# Conceptual Review Agenda

Schedule for 09/26/16 to 09/26/16

# 3555 Stanford Dr. Addition

December 05, 2016

**PARCEL INFO:**  
NORTH LOT PARCEL ID:  
9725313009

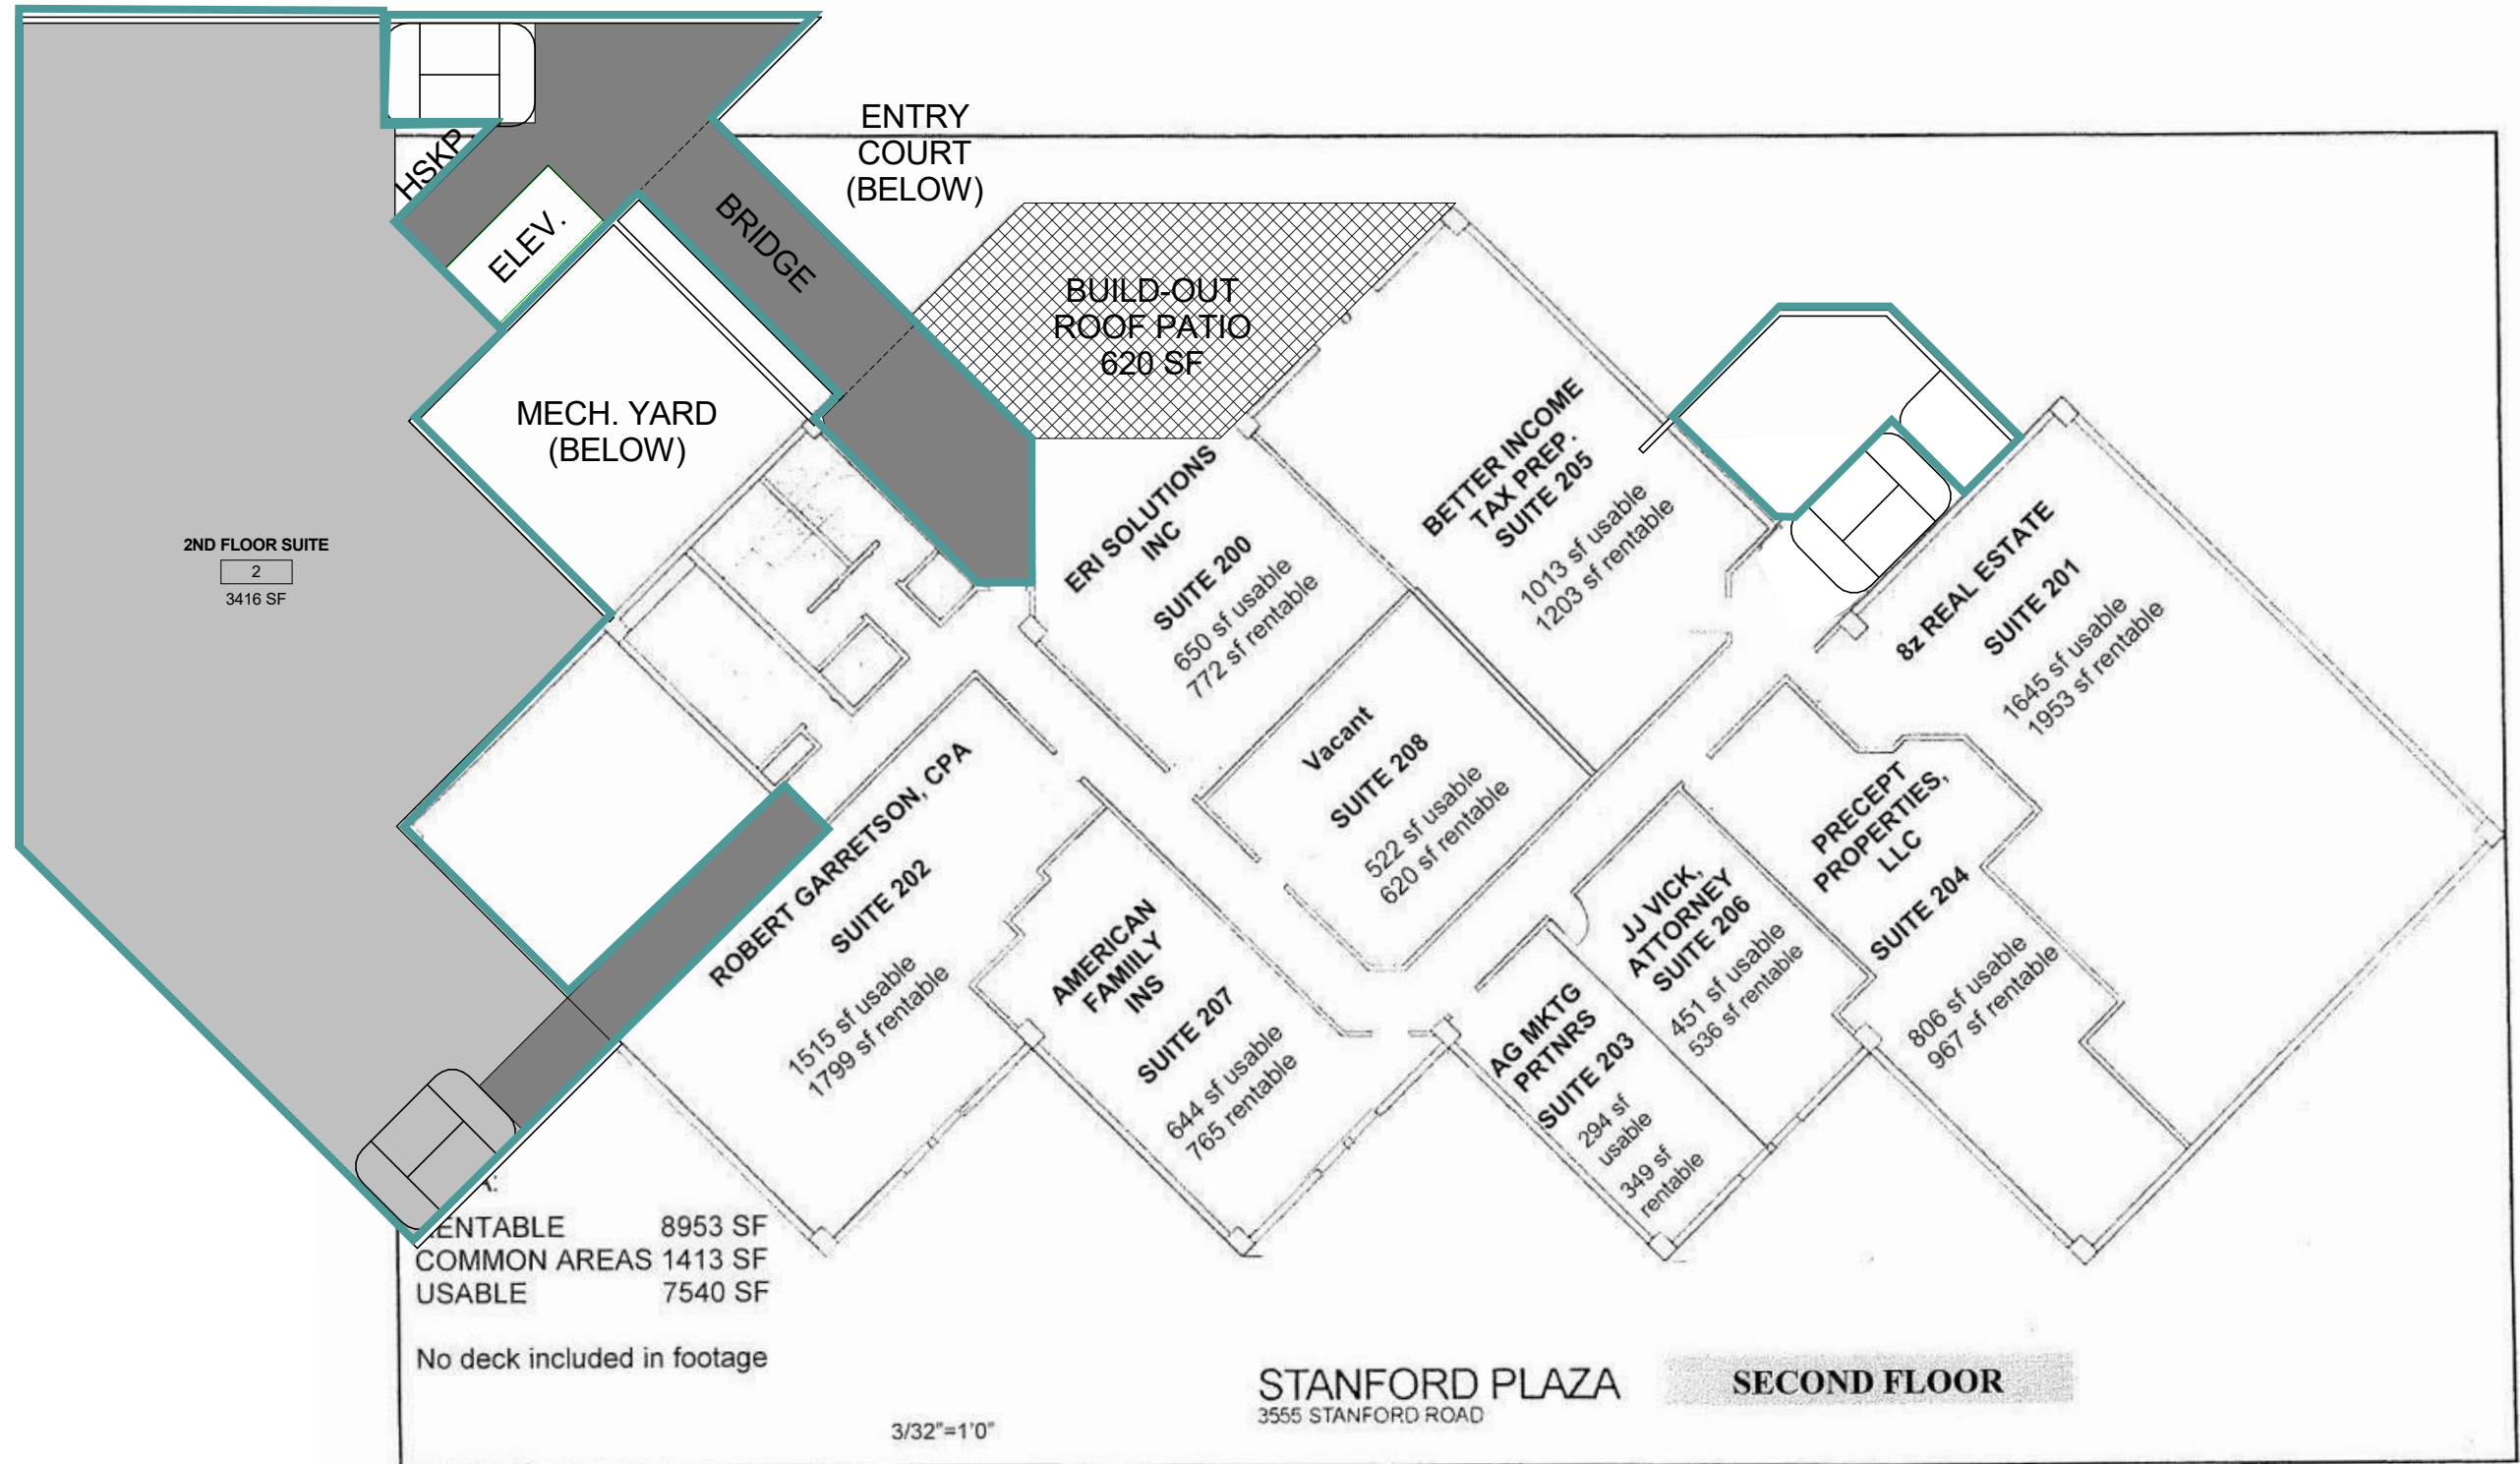
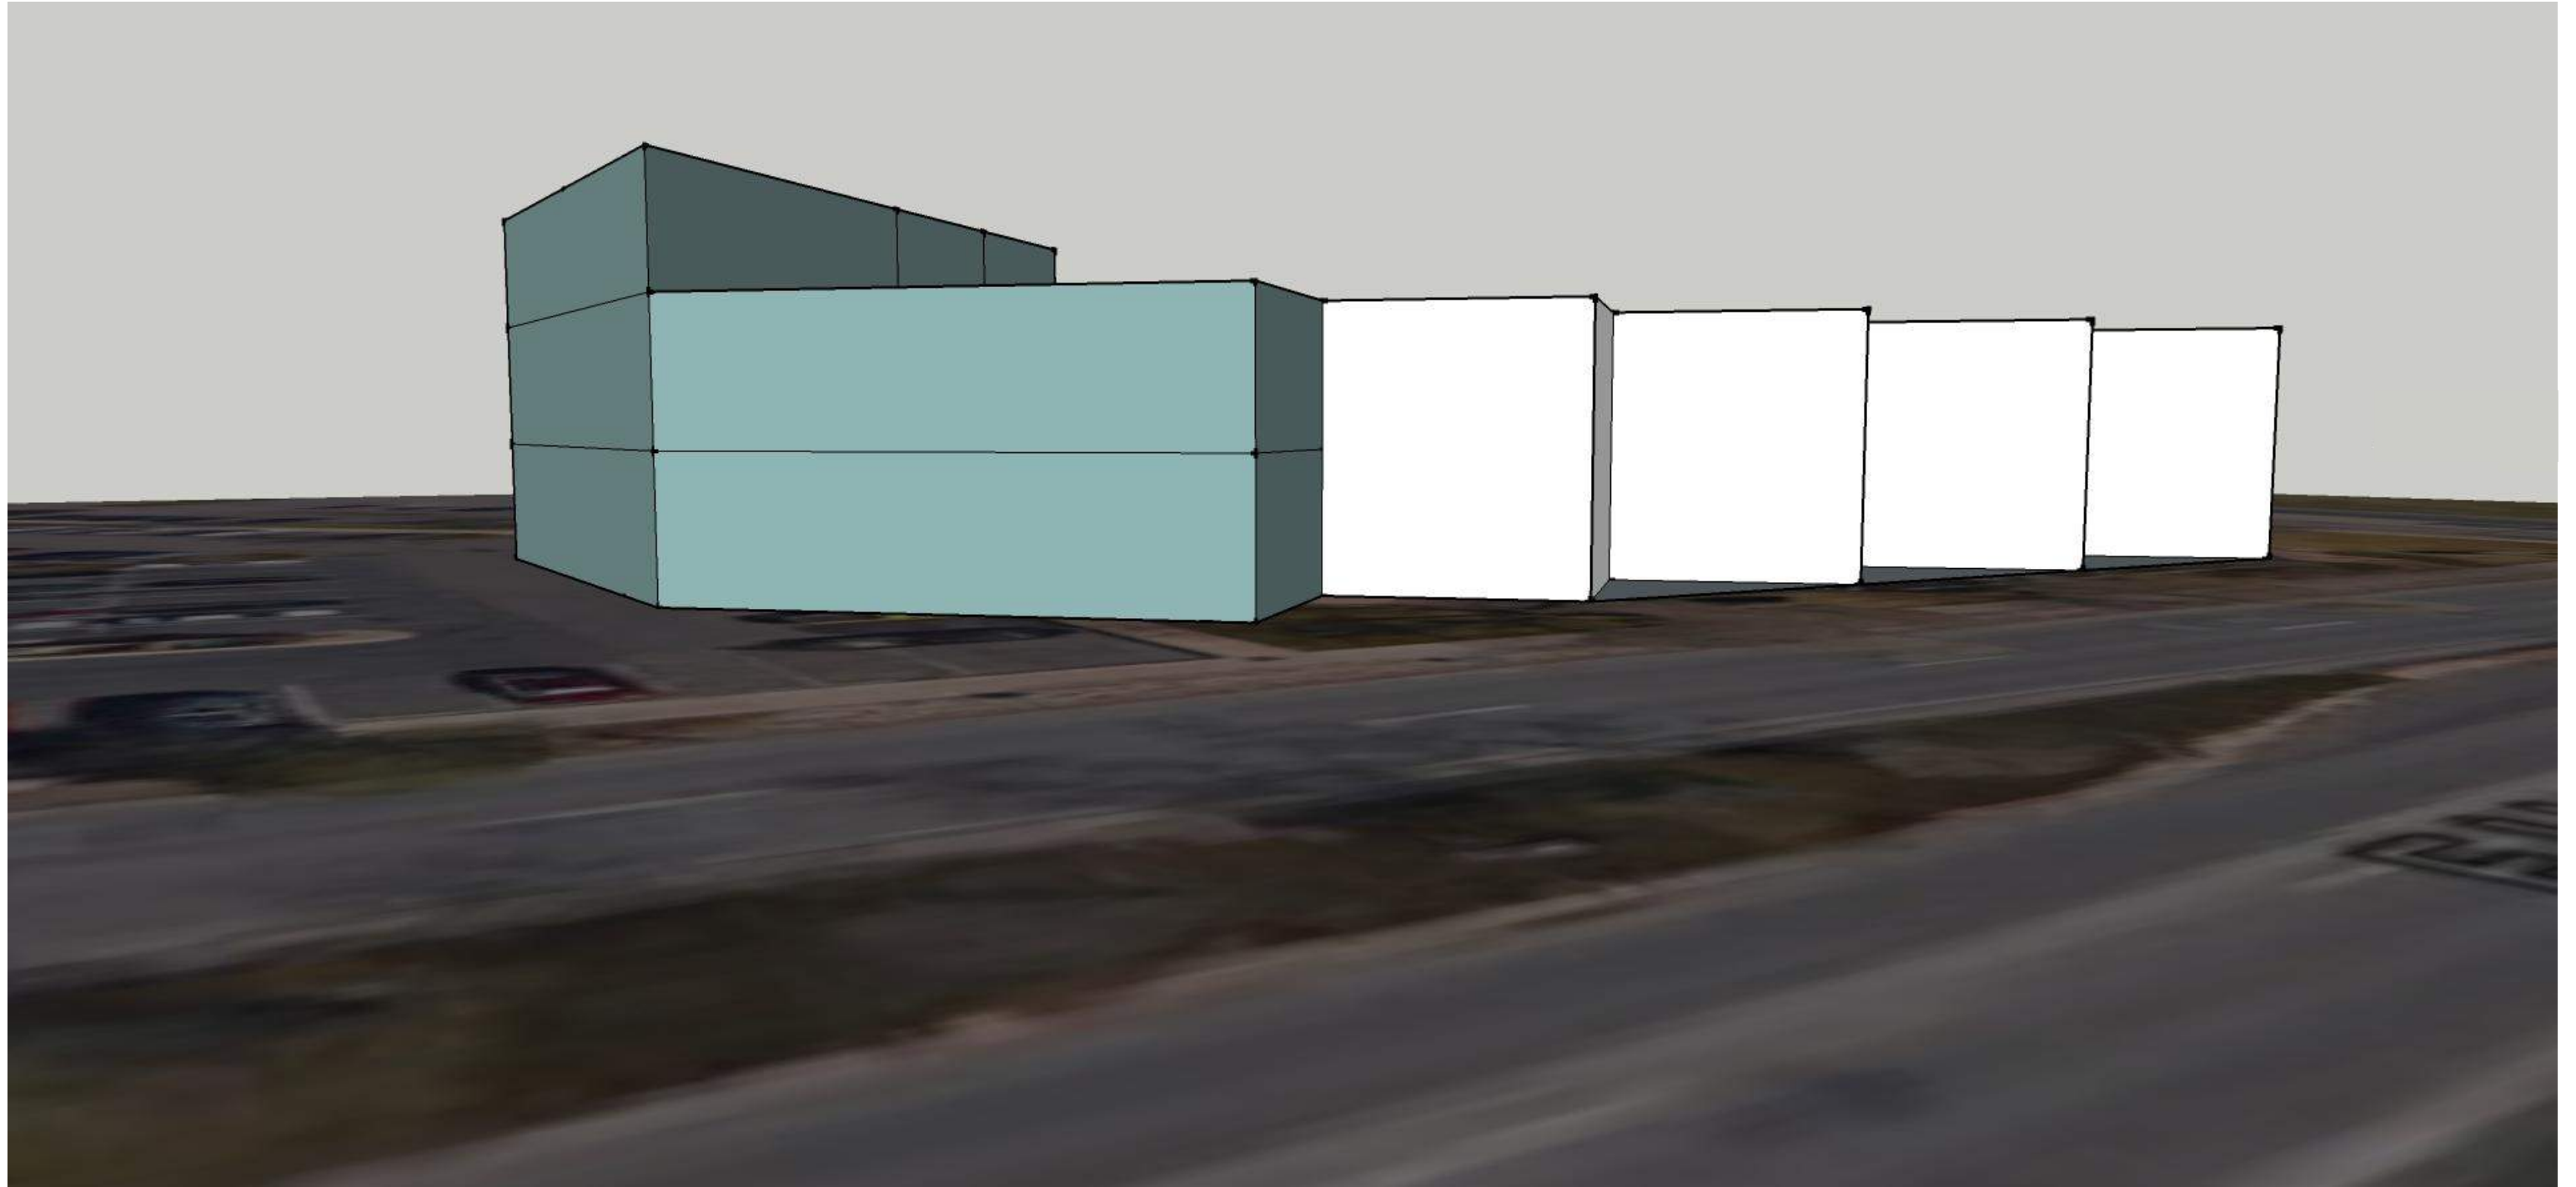
3. The provided exhibit indicates that you plan to re-route the existing storm pipes around the building addition. This is fine as long as there is sufficient slope (typical minimum slope on storm pipes is 0.40%) on the re-routed pipes and as long as drainage easements are dedicated along the new alignment. Also, we will want to make sure that all public stormwater pipes within this property are within a drainage easement, so if an easement
